## Capacity, Planning, and Safety Implications of Parkway Widening

The following report was prepared for WLSA's Board of Directors for their deliberations regarding Redmond's 2003 widening project. After a review of project information provided by Redmond, concerns still exist on a number of issues. Pertinent to all segments of the Parkway, the following analysis was intended to address unanswered questions raised by the project, including:

Steep And Angled Driveways Requiring Special Consideration

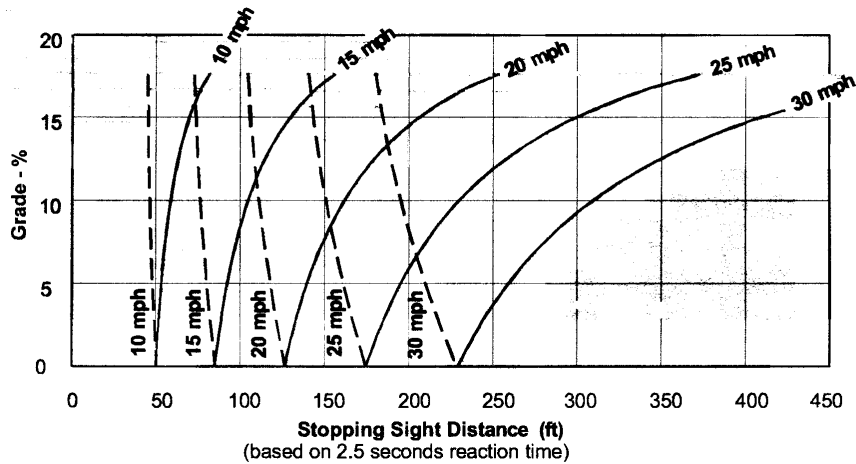
**Analysis:** Driveway approaches on the eastside of the Parkway are very steep in many sections, including within the limits of the proposed widening. In addition many are skewed, making it difficult for drivers to easily see on-coming traffic. Adding bike lanes would exacerbate these situations.
